The Bureau of Planning seeks design review of a proposed revision to the project approved at 325 7th Street.

One May 25, 2018, the applicant submitted a revision to the previously approved design that changes the design of the building and also changes the following:

Case File: CMDV06573 - R01
Applicant: 325 7th Street, LLC
Address: 325 7th Street
Zone: D-LM 2 & D-LM 4
Height Area: LM-275

REFINED DESIGN - TYPICAL FLOOR PLATE OF TOWERS

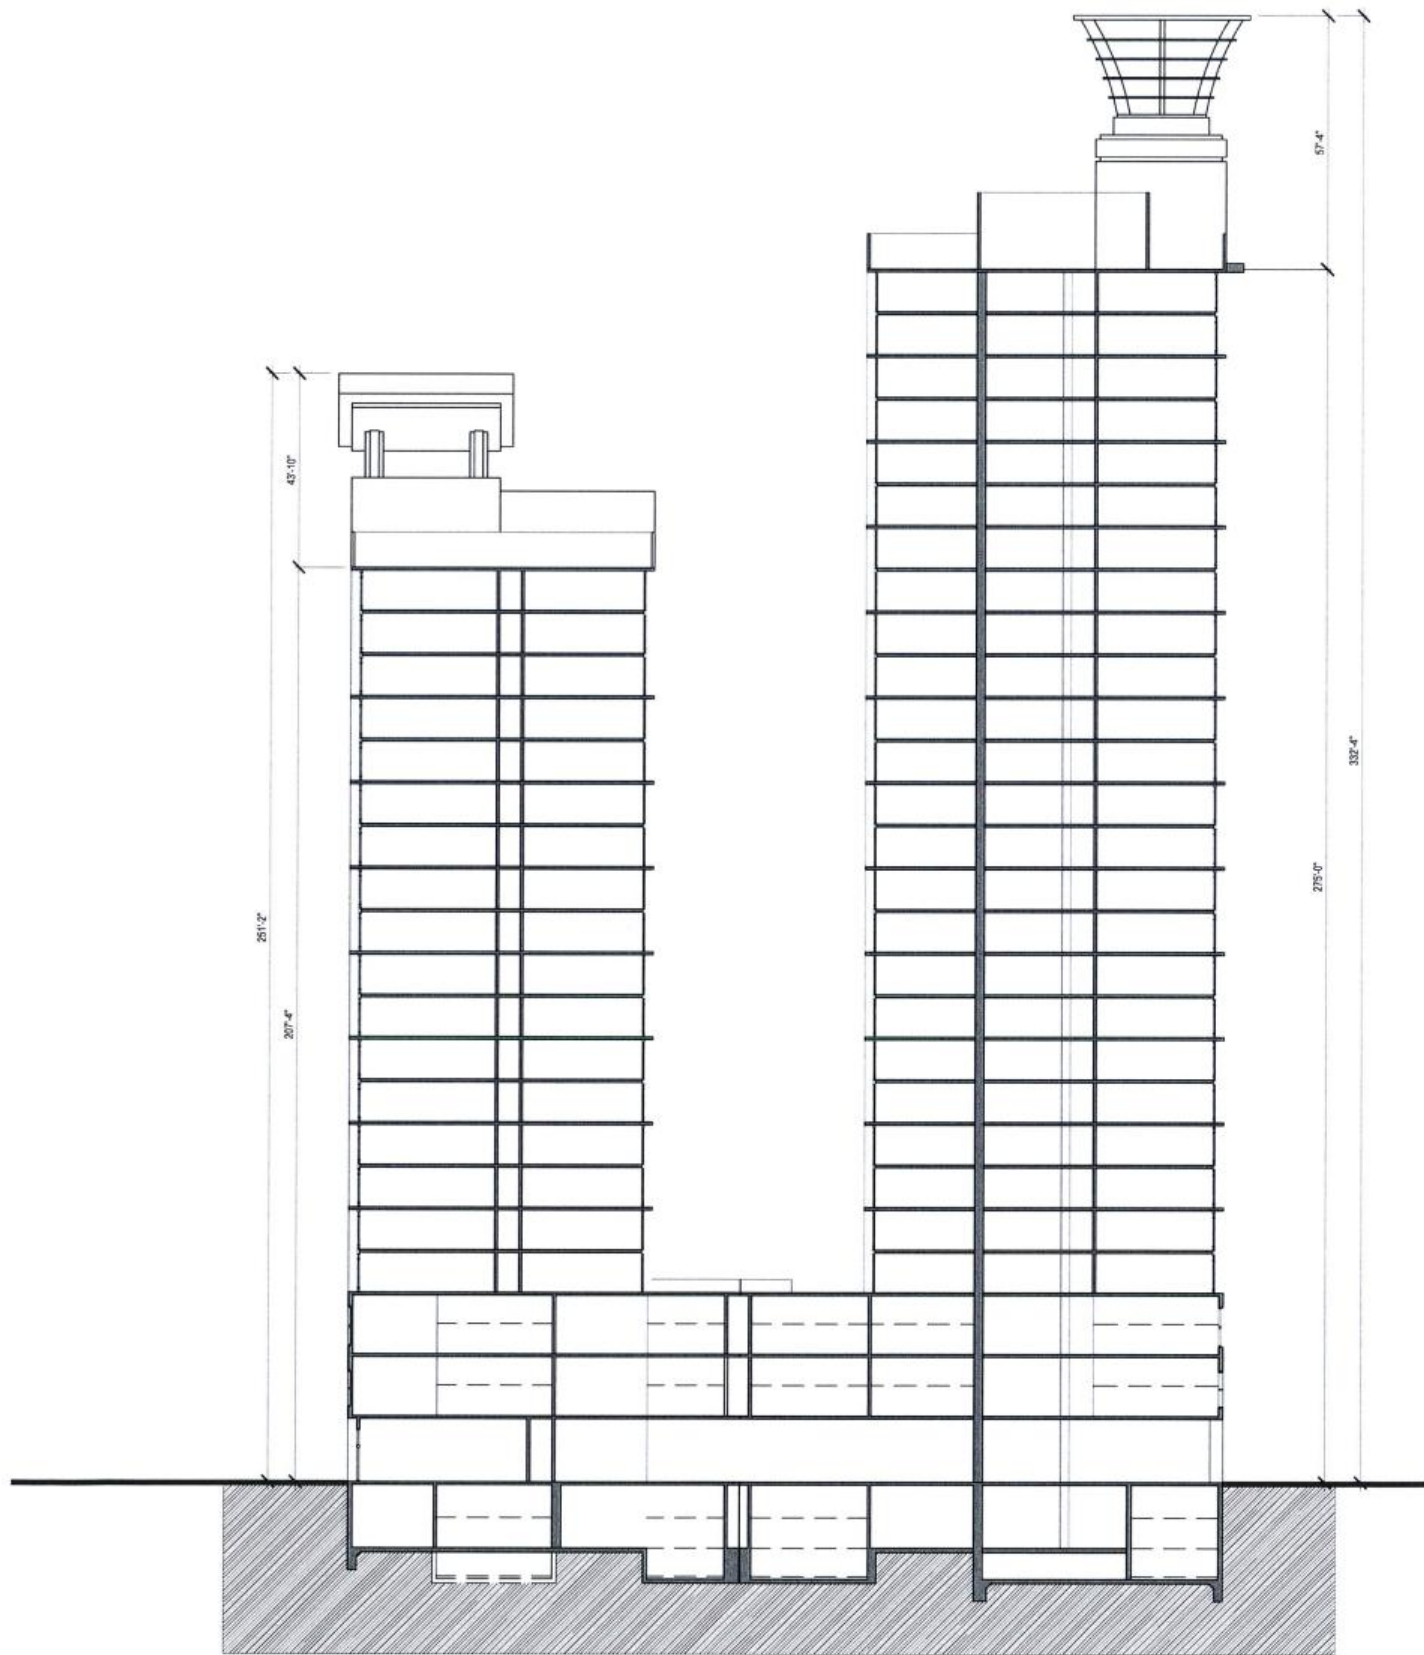
The massing and composition of the proposed revision to the design (especially the architectural feature at the top) appear bulky and monolithic. Staff believes there are opportunities to do something compelling and outstanding however, as the proposed building top appears like a mere penthouse. The to should provide an elegant building terminus in terms of articulation, materials and details. Further, the penthouse structure does not comply with OMC code section 17.108.030 for allowed projections over the height limit for applicable architectural features in that, it exceeds 10 percent of the aggregate
